RE: New York SMSA Limited Partnership d/b/a Verizon Wireless installation of a public utility personal wireless facility at the property known as 52 Montrose Station Road, Town of Cortlandt, NY

In connection with the Facility, we received comments from the Town's Director of the Department of Technical Services, Michael Preziosi, P.E. ("Town Engineer") on March 11, 2019 and the Town's Consultant, The Center for Municipal Solutions ("Town Consultant"), dated April

Response to the Comments from Town Engineer:

Z6 6 of 11

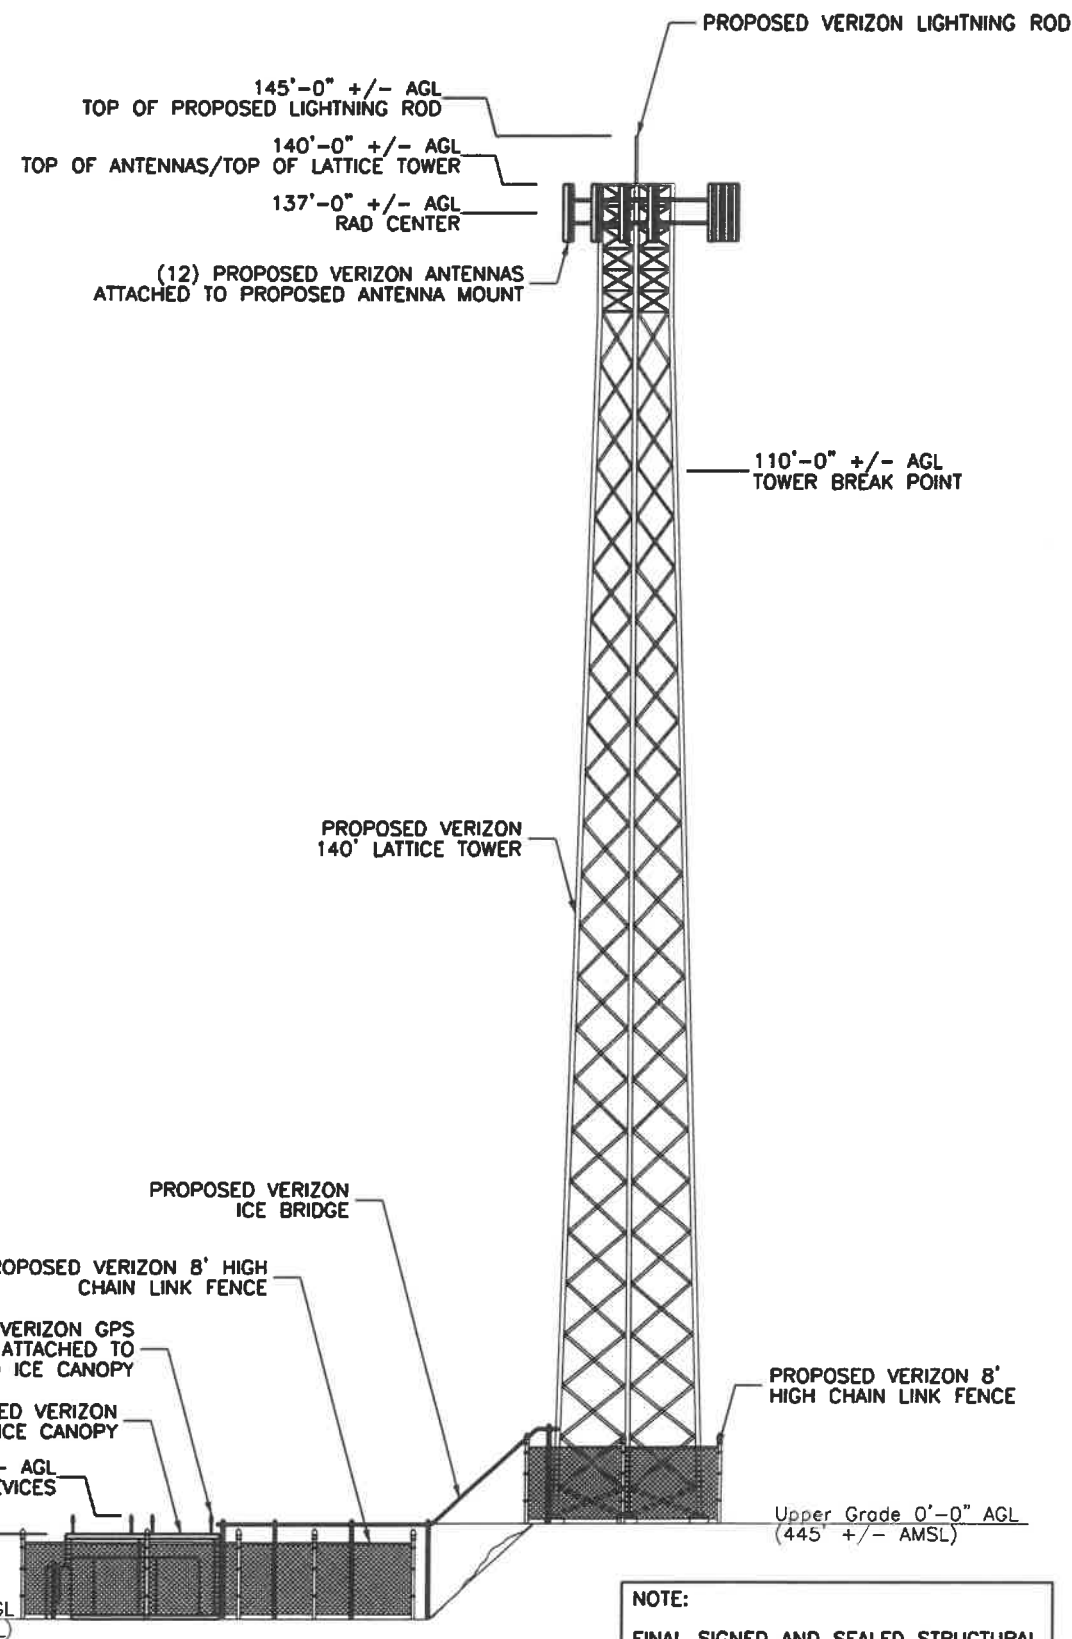
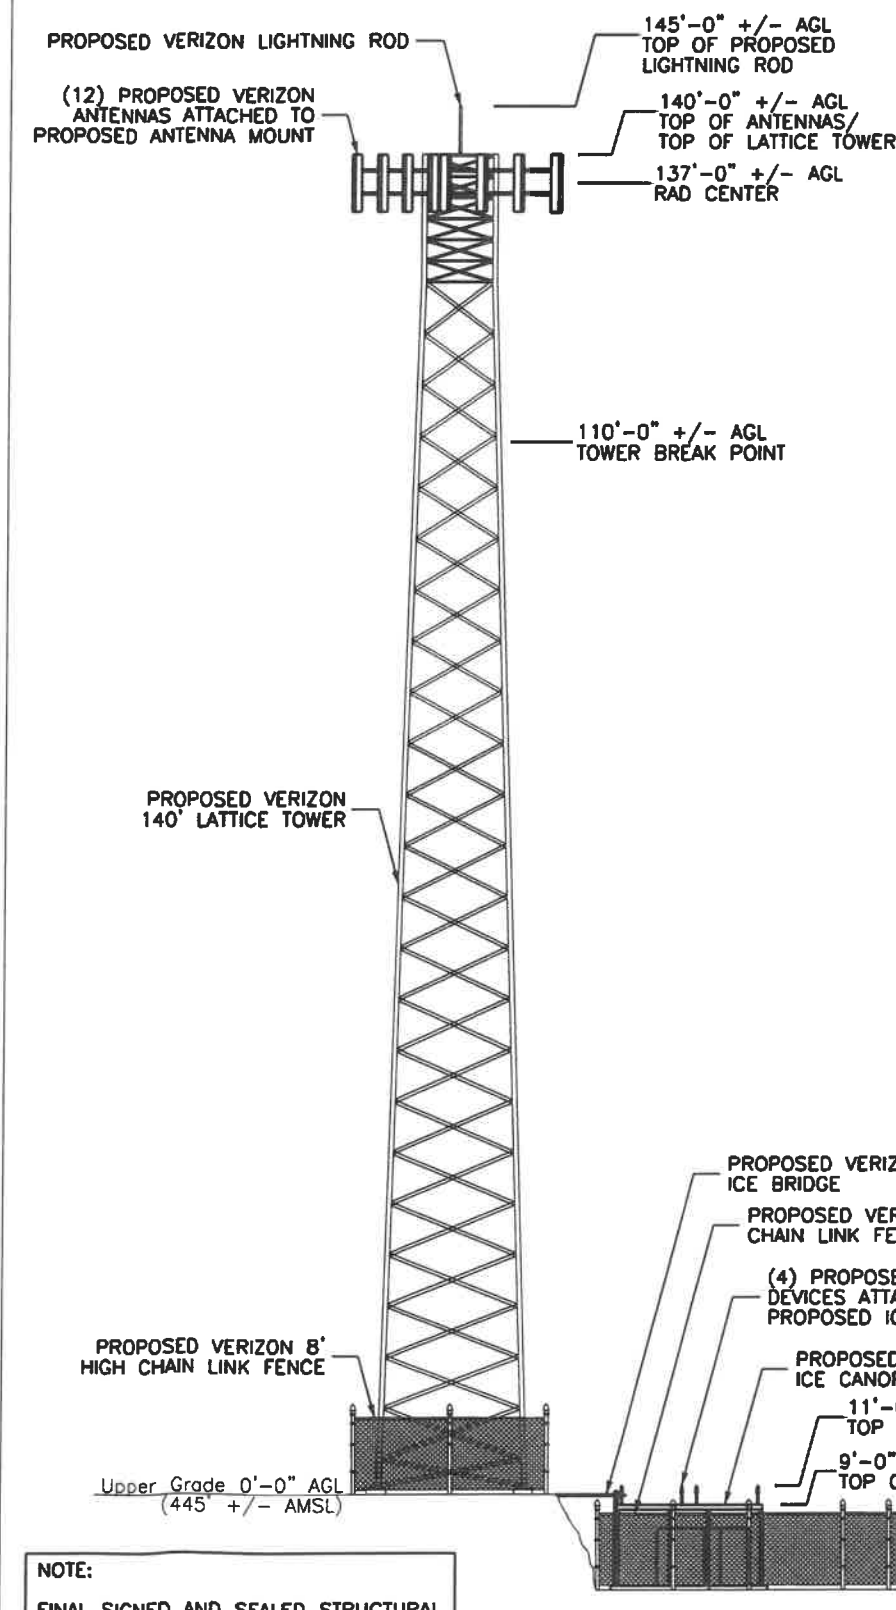
Comment #2: *The break point and collapse zone has been improperly identified. The Applicant shall read the definitions of breakpoint and collapse zone in sections 277-4 and 277-6(H) of the Town's ordinance.*

Comment 14: Pursuant to Section 277-6(H), "Certification by a licensed engineer that the telecommunications tower is designed with a break point that would result in the telecommunications tower falling or collapsing within the boundaries of the property on which the telecommunications tower is placed." Applicant has submitted a Structural Certification letter (Scherer Design Group, LLC, dated 2/8/19, signed by Colleen Connelly, P.E.), which certifies that "The proposed Tower, all attachments, and the Tower's foundation will be designed to meet the ANTI/TIA-222-G [sic] 'Structural Standard for Antenna Supporting Structures and Antennas' and all county, state, and federal structural requirements for loading, including wind and ice loads." The Applicant has not provided the required break point analysis.

Response: As indicated on Pages Z5 and Z6 of the Revised Plans, a break point has been incorporated into the tower design in accordance with Sections 277-4 and 277-6(H) of the Town Code.

Response: As noted above, once the tower design has been approved by this Honorable Board, SDG will work with the tower manufacturer to obtain the final "full and complete" structural analysis, including any required break point analysis. As indicated on Pages Z5 and Z6 of the Revised Plans, the tower is being designed with the requested break point. It is therefore respectfully requested that any required break point analysis be a condition of the building permit approval.
